AGENDA
HISTORIC PRESERVATION BOARD
City Commission Chambers
March 23, 2023 8:30 A.M.

AGENDA
DESIGN REVIEW COMMITTEE
March 23, 2023

- B. [HPB23-032 – 801 E. Main Street](#) – Final Approval requested for the installation of an illuminated wall sign on the principal building of the subject property. Owner: Ten Cap Partners LLC. Applicant: Mr. Roger Snyder and Mr. Ryan Birt, Dixie Signs Inc.

- C. [HPB23-040 – 727 Jefferson Avenue](#) – Final Approval requested for the new construction of a covered stoop onto the front elevation of the house on the subject property. Owner/Applicant: John and Valerie Tutton.

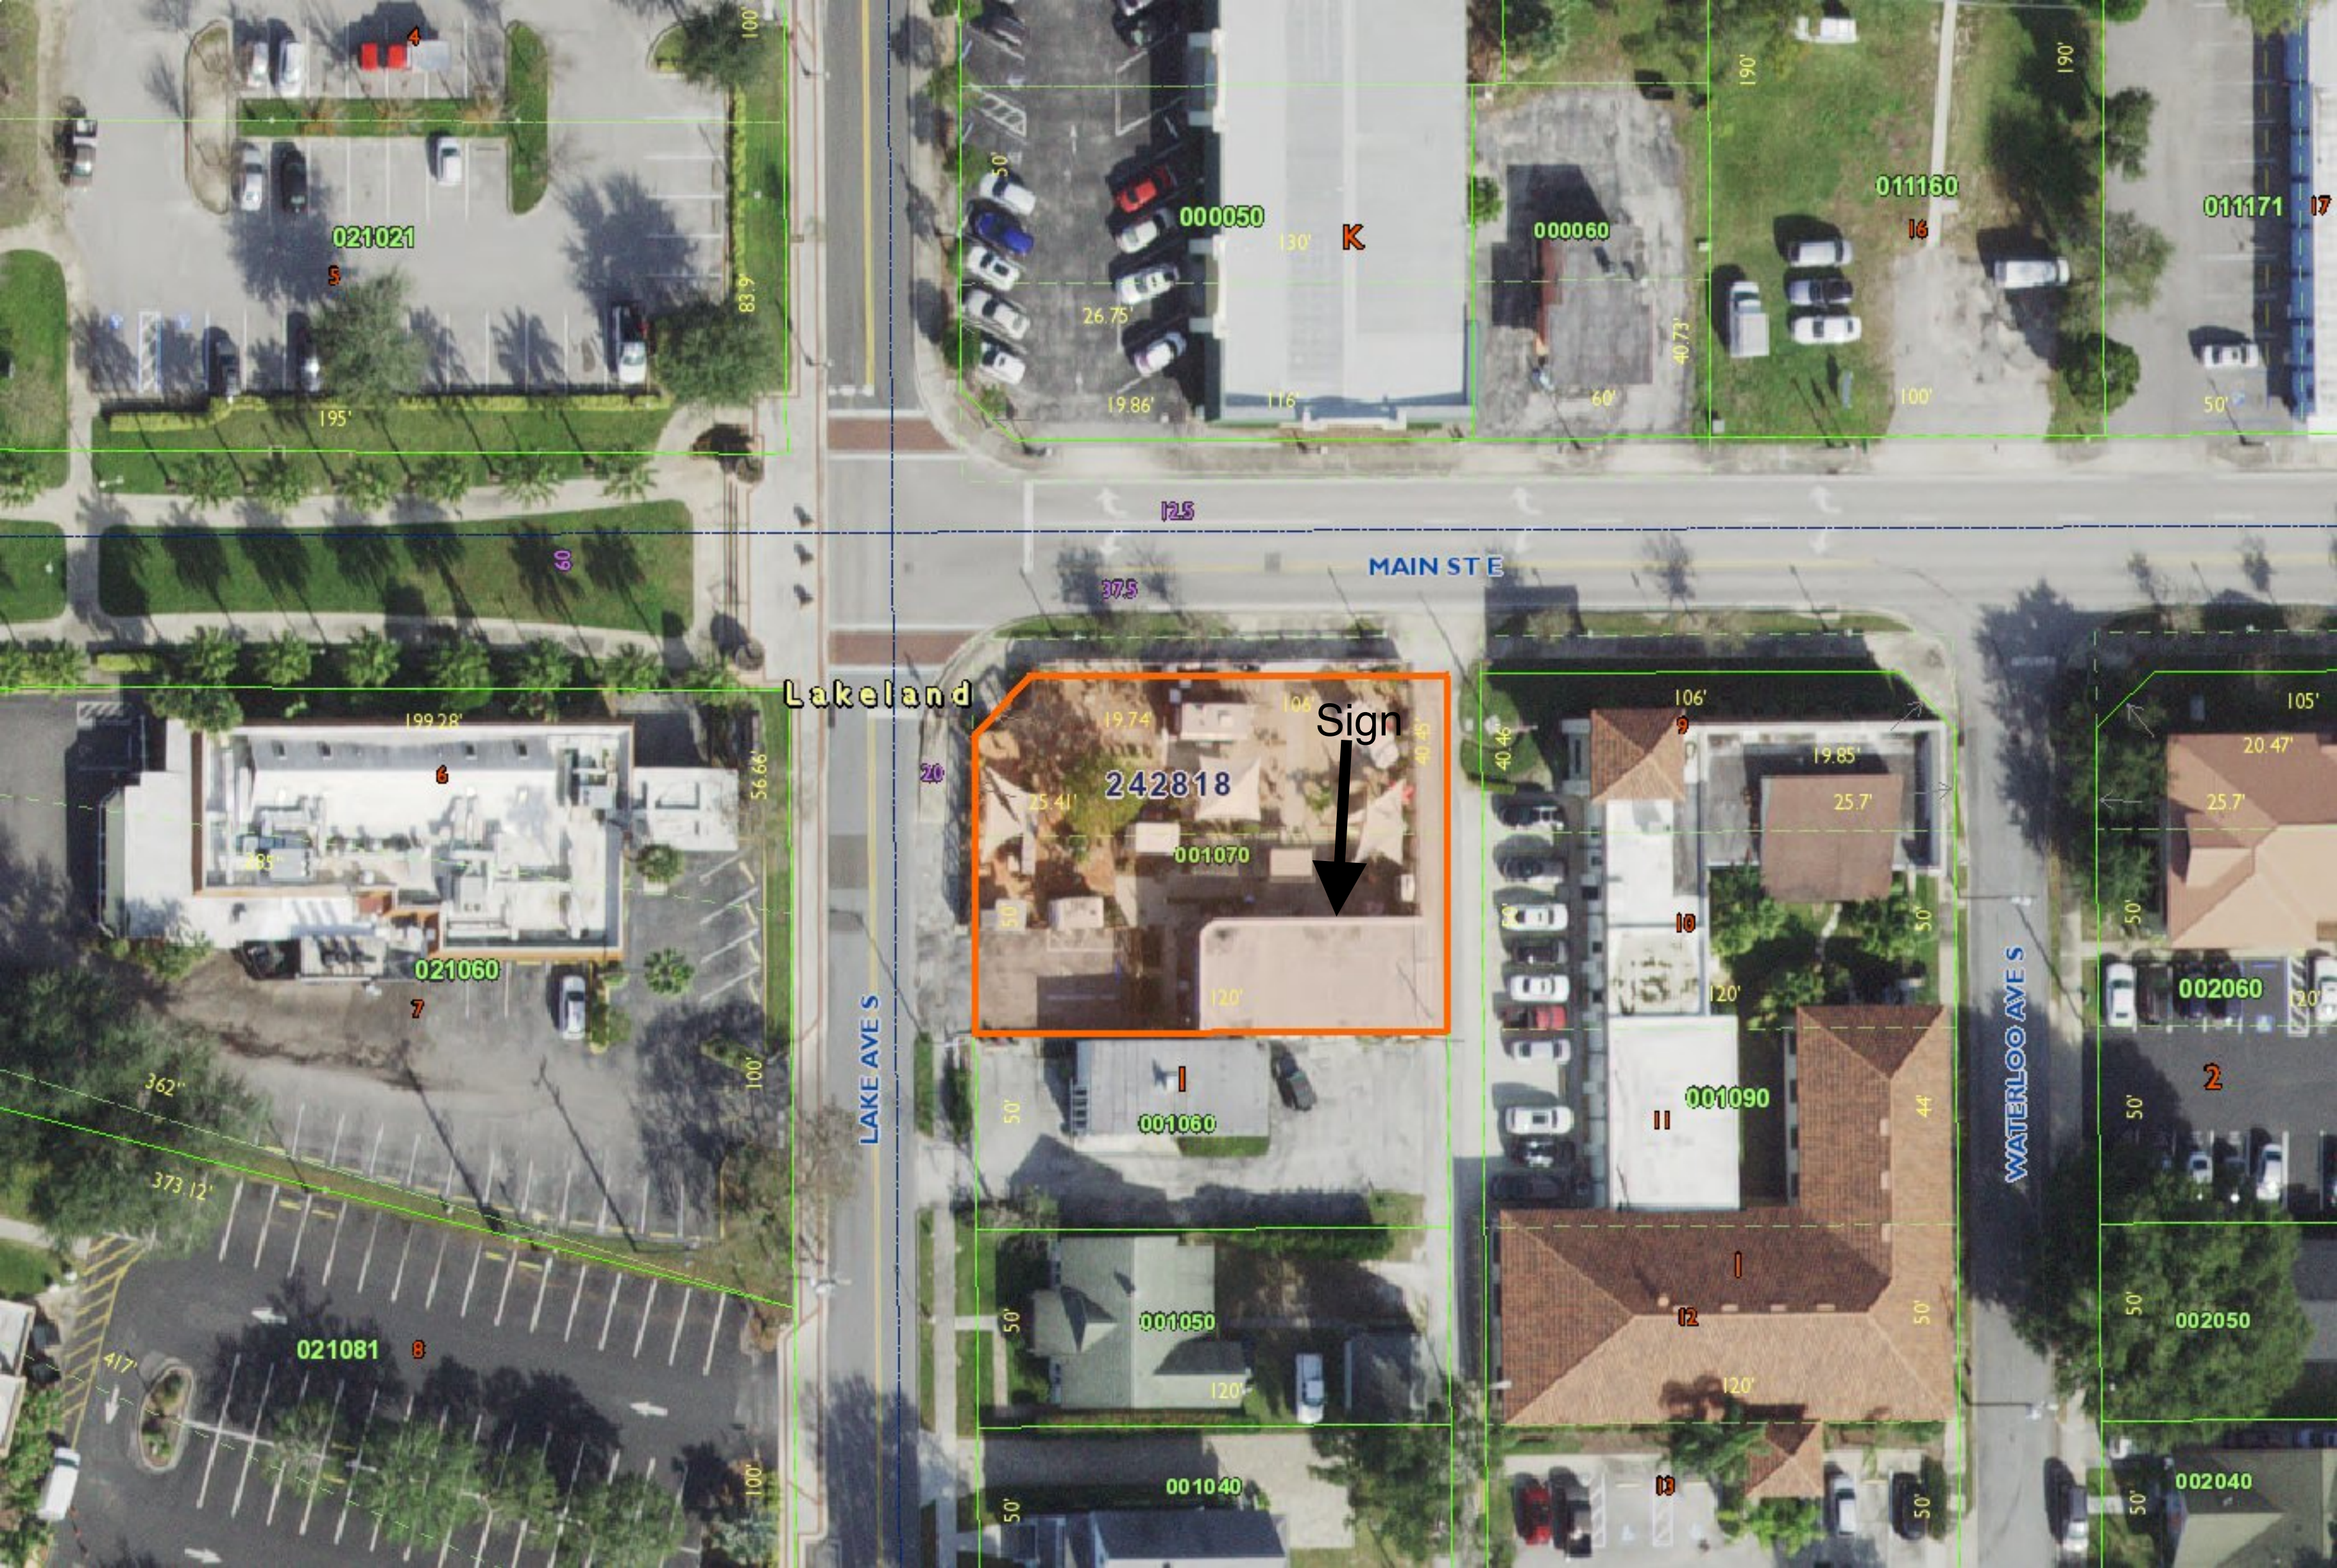
The Design Review Committee previously approved an exposed neon sign on the west elevation wall for the Poor Porker. Staff finds that the design of the proposed sign is acceptable under the Dixieland Guidelines, and the placement and scale of the sign on the upper portion of the building's north elevation wall is appropriate. The individual letter internal lighting source for this sign is found appropriate, as this type of illuminated sign was common on many Mid-Century Modern buildings, and is also found in the East Main Street District, located near the subject property east of Bartow Road (U.S. 98). However, the size of the sign is slightly too large according to the Dixieland Guidelines and must be reduced to no more than 48.66 square feet, based on Dixieland Guideline 2.a. listed above.

PROPOSED FRONT ELEVATION

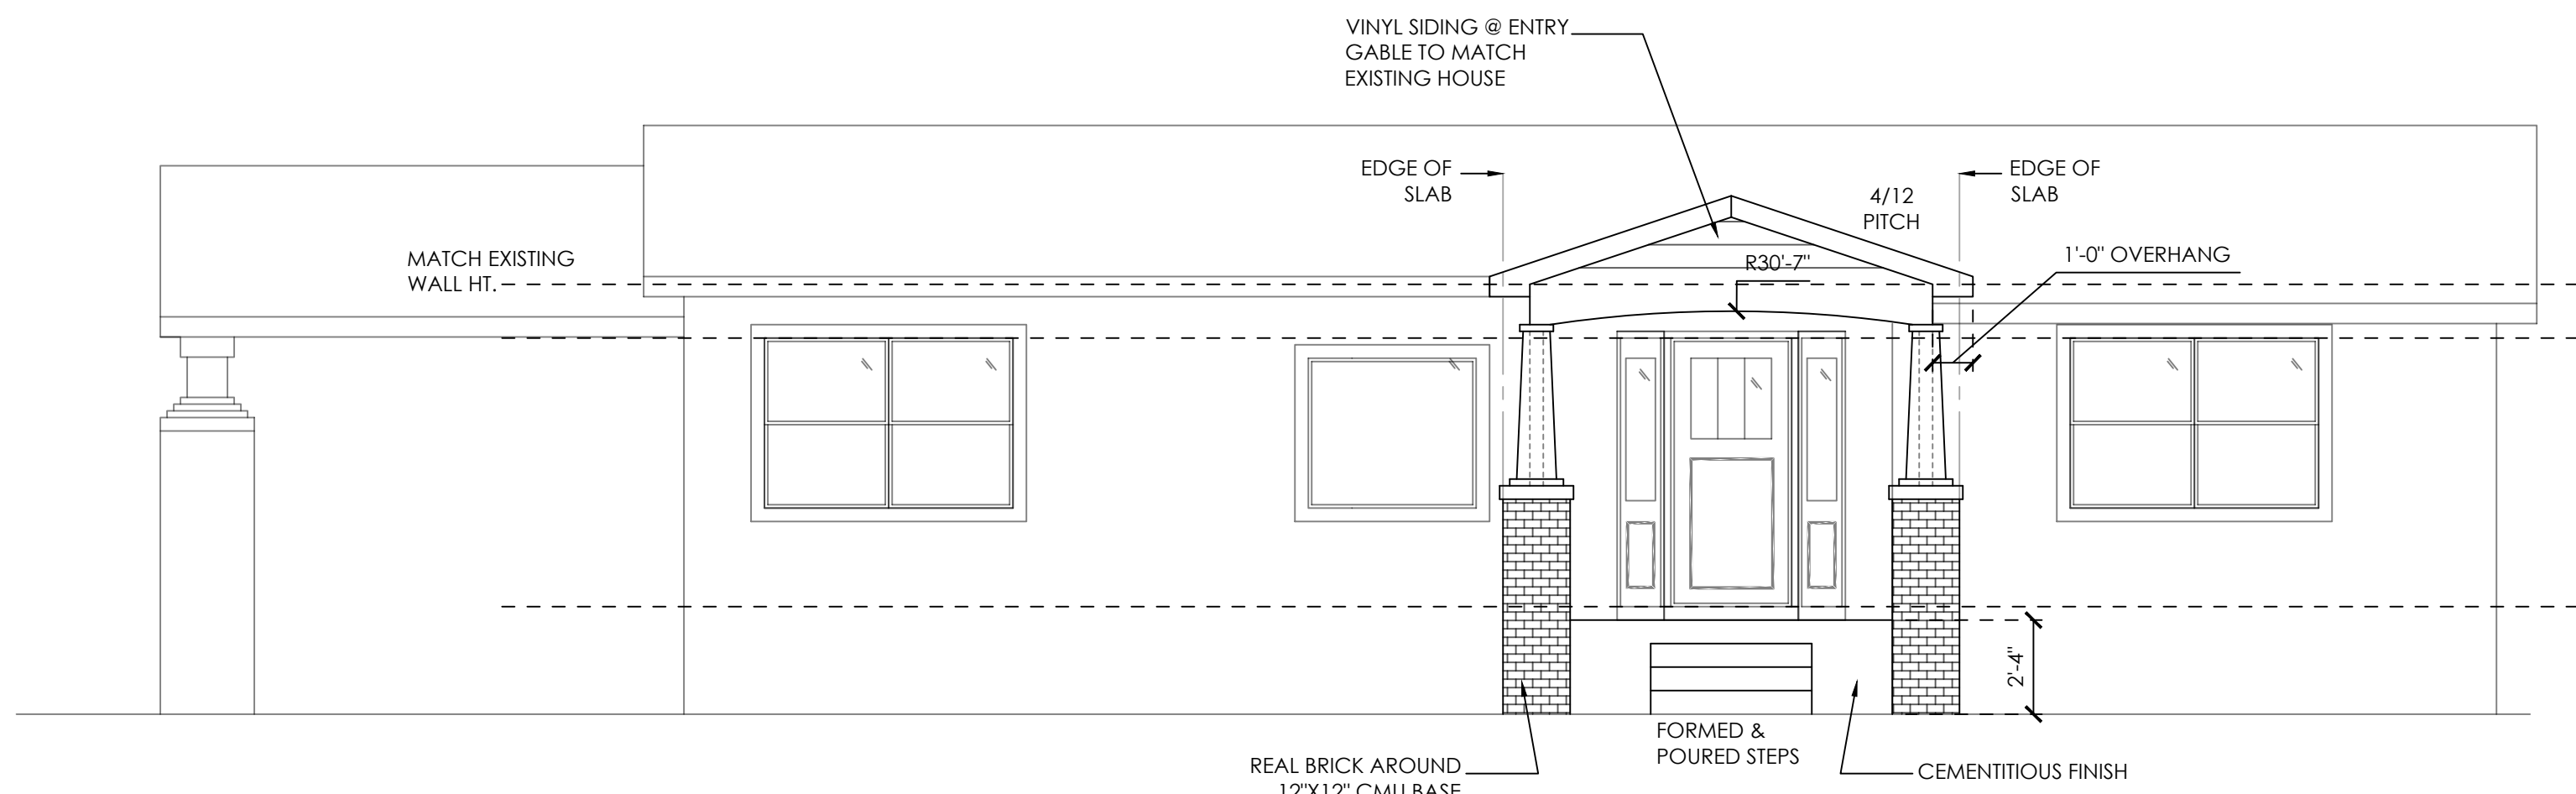
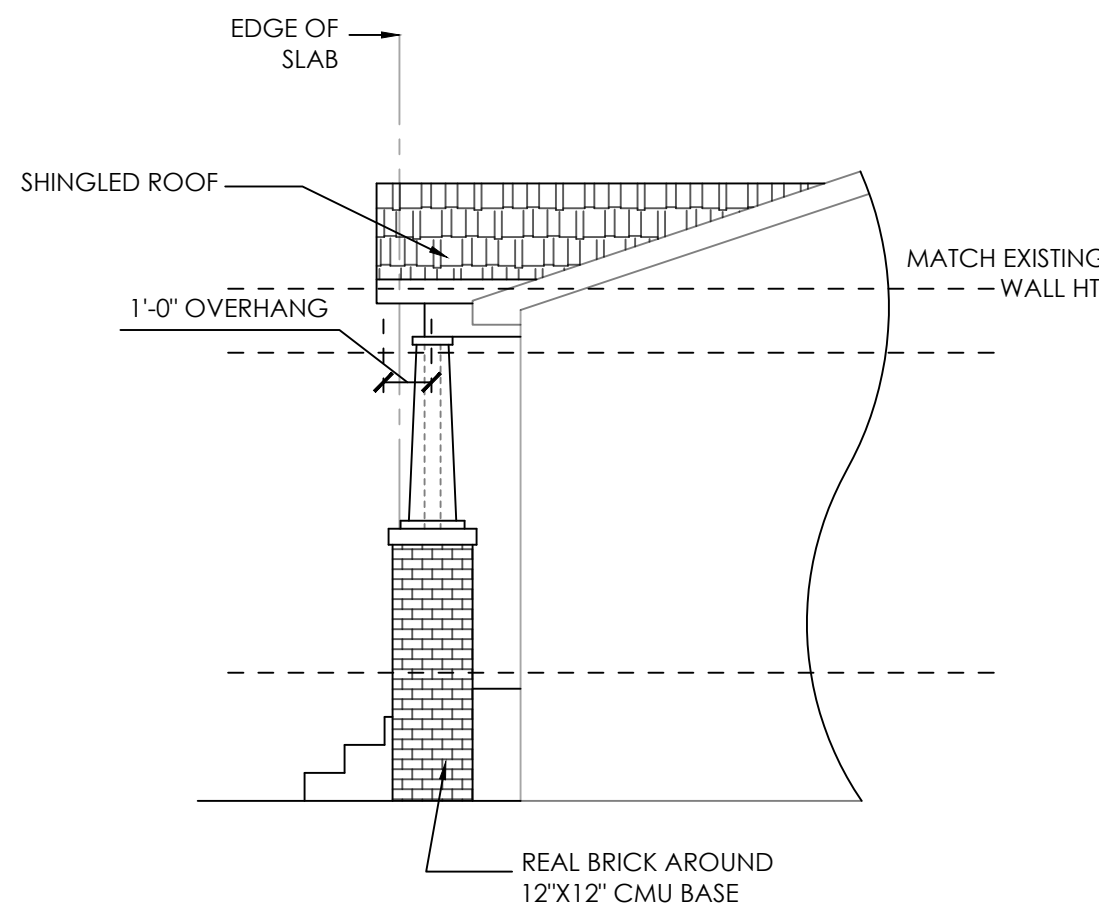
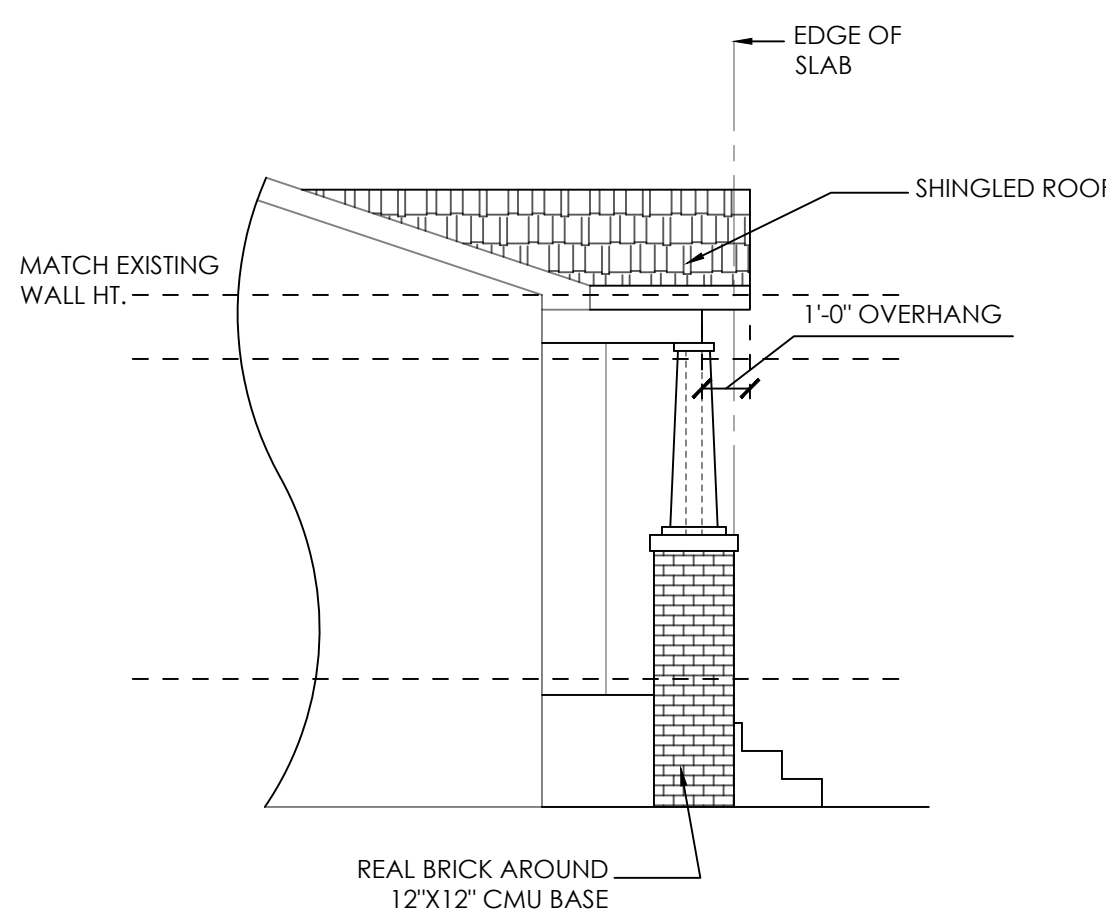
The request proposes to remove the existing roof overhang and steps at the entrance on the home's front elevation and add a covered front stoop measuring 3'-4" deep by 10'-8" wide (35.6 SF). The new stoop will feature a gable-front appearance, with a 4/12 roof pitch, supported by tapered columns on brick plinths. The stoop will have a raised foundation covered in cementitious finish and concrete steps. The Applicant's reason for this request is threefold: to replace the damaged awning and provide additional cover; to provide for a safer landing for ingress/egress; and to resolve front door leaks in the future. Materials to be used in the porch addition are as follows:

1. Use fiber-cement lapped siding with an exposure width similar to the lapped siding on the house in the stoop gable.
2. Use tapered columns in the style and proportion of the columns supporting the porte cochere for the stoop columns.
3. Straight eave returns should be used on the gable of the stoop.
